Conway Planning Commission Staff Report

7:00pm • February 20 2018 • 810 Parkway Avenue

CONWAY CITY PLANNING DEPARTMENT REVIEW WEATHERSTONE PHASE III SUBDIVISION PRELIMINARY PLAT

WEATHERSTONE SUBDIVISION PHASE 3
CITY OF CONWAY
PRELIMINARY LOT PLAN

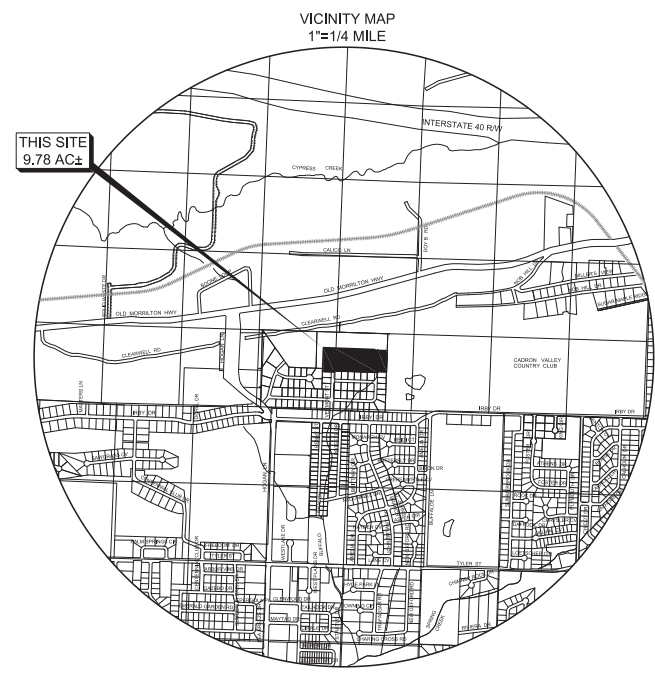
1. A legal description of the property with exact boundary lines, bearings and distances is needed. Correction needed on North Boundary Line length.
2. The Certificate of Preliminary Plat Approval is needed. Add "Jerry Rye" as Chairman.

3. The direction of flow of all water courses entering the tract shall be indicated.
4. The direction of flow of all water courses leaving the tract shall be indicated.
5. The drainage area of all water courses above the points of entry shall be noted.
6. The downstream drainage channel and drainage structures substantially impacted by the subdivision/replat shall be shown.

7. Minimum floor elevations shall be placed on the plat for all lots less than three (3) feet above the computed one hundred (100) year flood elevation. The minimum finished flood elevation shall be established at one (1) foot above the computed one hundred (100) year flood elevation.

8. Storm water detention or another storm water flow reduction measures shall be provided where existing downstream subdivisions or developments have storm drainage systems with a capacity of less than a ten (10) year frequency storm. The requirement does not apply to the inadequate natural streams or creeks flowing through undeveloped areas. The storm water detention facilities shall be designed to provide a holding area such that storm water runoff can be accumulated and released through at an outlet structure. The required storage volume and outlet structure shall be sized to release the storm water at a rate that does not exceed the capacity of the downstream storm drainage system or a computed runoff rate equal to that of the pre-development conditions of the proposed development, whichever is the greater. The detention facilities shall be based on a twenty-five (25) year frequency storm event. Computations for the sizing of the detention facilities and outlet structure shall be prepared by a registered professional engineer and submitted to the City Engineer for review and approval. The computations shall be made using usual and accepted methods and procedures as approved by the City Engineer.

11. Plat approval subject to Engineering approval of street and drainage plans and drainage report.
12. In the case of temporary deadend streets, more than 150 feet in length, which are stub streets designed to provide future connections with unsubdivided adjacent areas, the Planning Commission may require a temporary easement for a turnaround. ***Millford Dr. has a dead-end street which exceeds 150', but does not detail an approved turn-around. The Planning Commission Approves / Disapproves of this condition.***

13. Fire hydrants must be placed so that the furthest point of a lot in a residential subdivision is no more than 600 feet from the hydrant located on the same street. Variances must be approved by the Planning Commission and Fire Chief.
14. Utility easements as required by Conway Corporation are needed.

Staff recommends the approval of the preliminary plat subject to the amended punch list.

Proposed new lot configuration

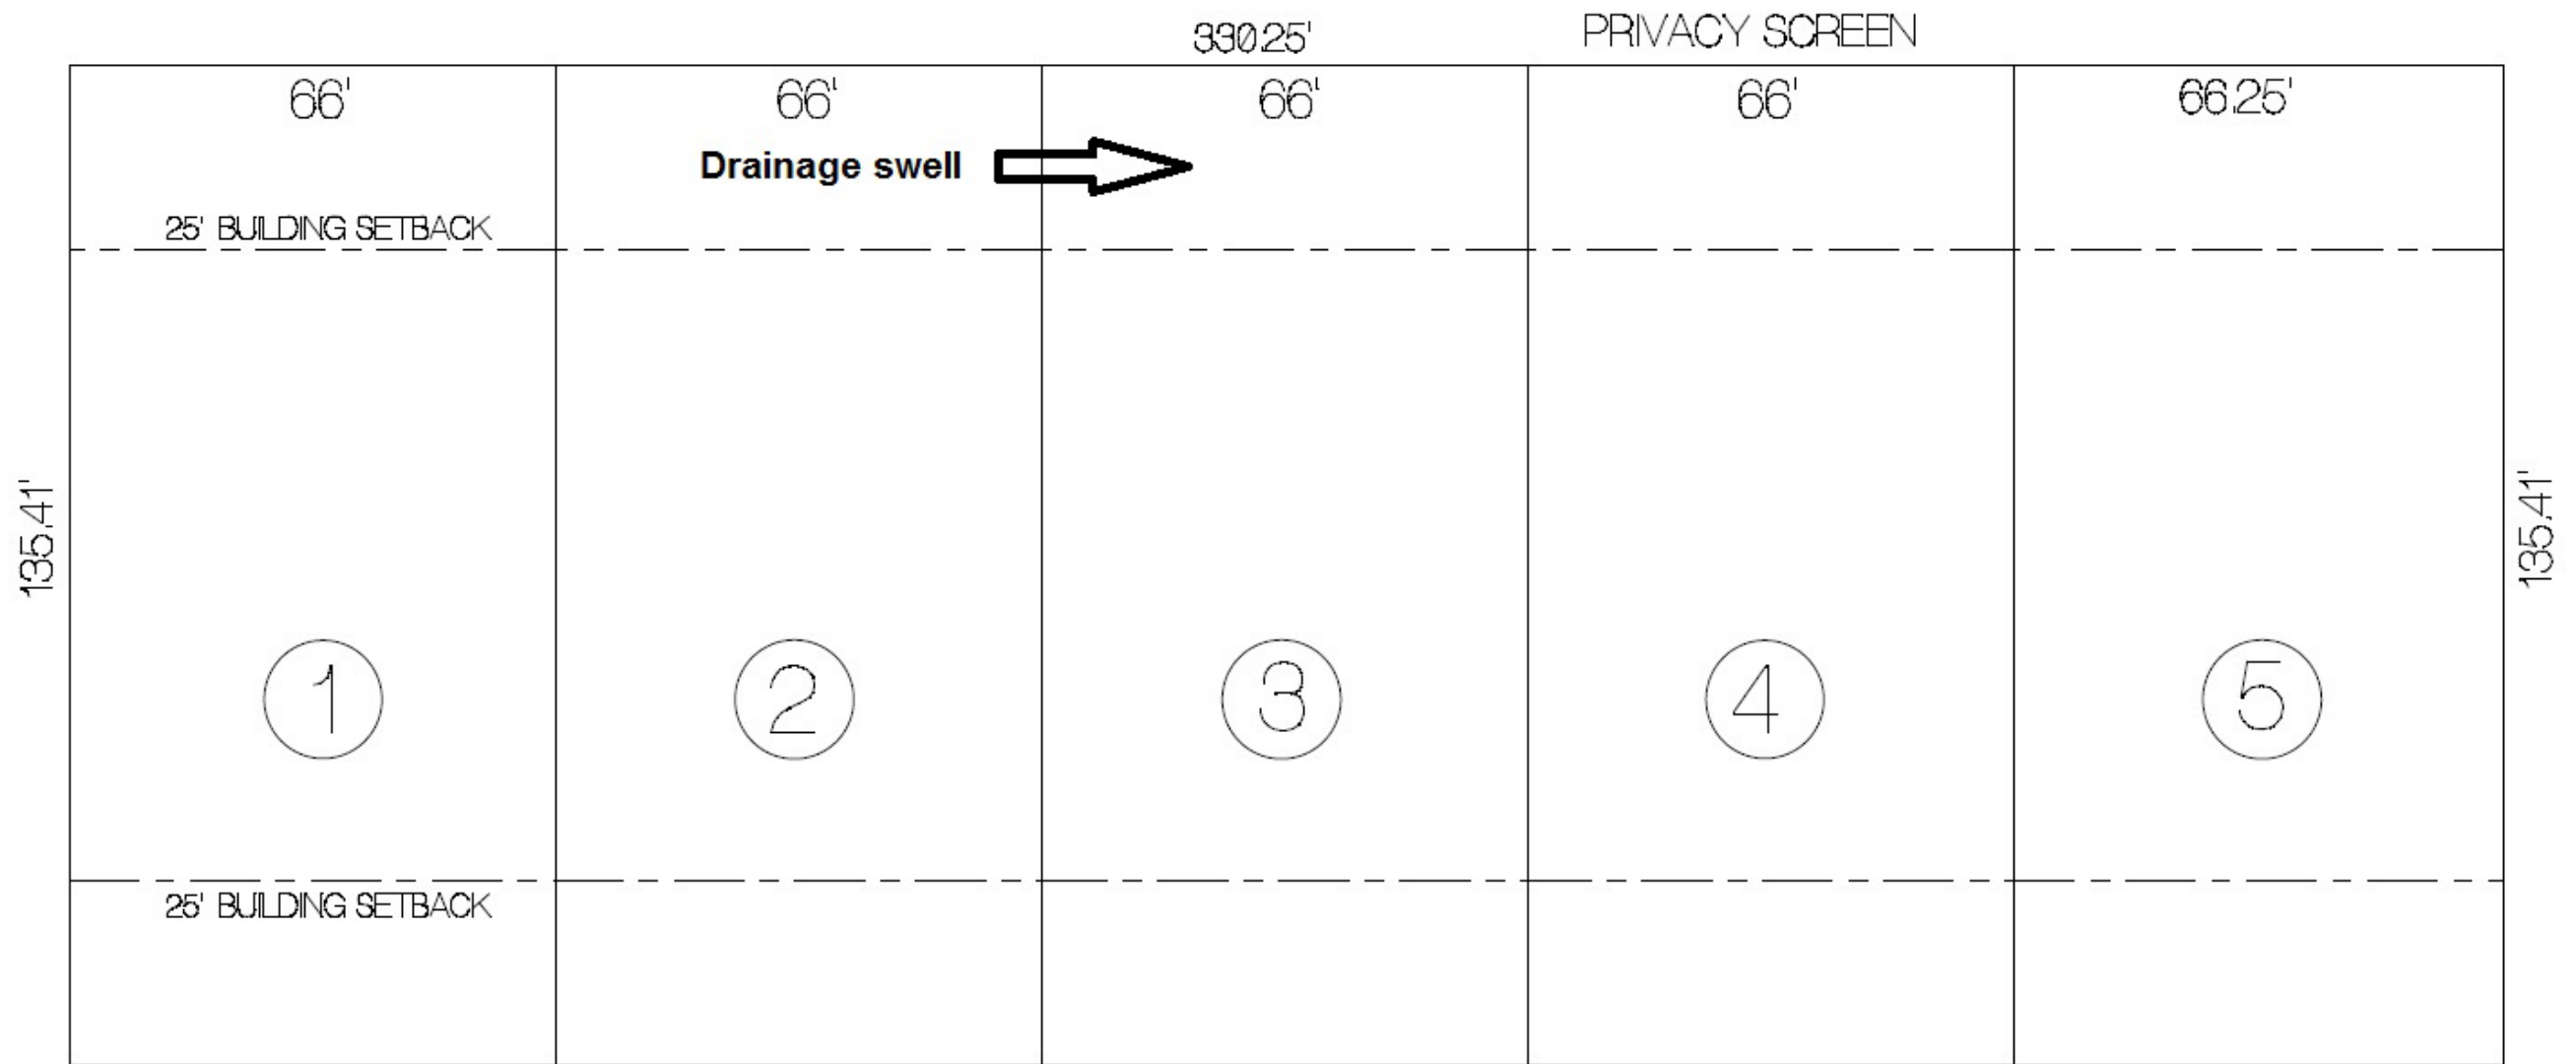
The proposed PUD modification will create 5 smaller lots from 3 large single family lots. The proposed lots will be substantially larger than the Zoning Ordinance minimum R-1 single family requirements. The proposed setbacks match R-1 zoning requirements.

Each lot will have individual driveways. Individual driveways have not proven to be a problem for passing traffic on similar streets with residences such as Farris and Salem.

1. Lots shall be re-platted at approximately 66 feet wide and 135 feet deep (8910 s.f.)
2. Setbacks shall be 25 feet front and rear, 6 feet on sides.
3. A drainage swale shall be created in the rear setback area to help with neighboring drainage problems.
4. Second story windows shall be prohibited on the north and west facades.
5. Individual driveways shall be allowed.
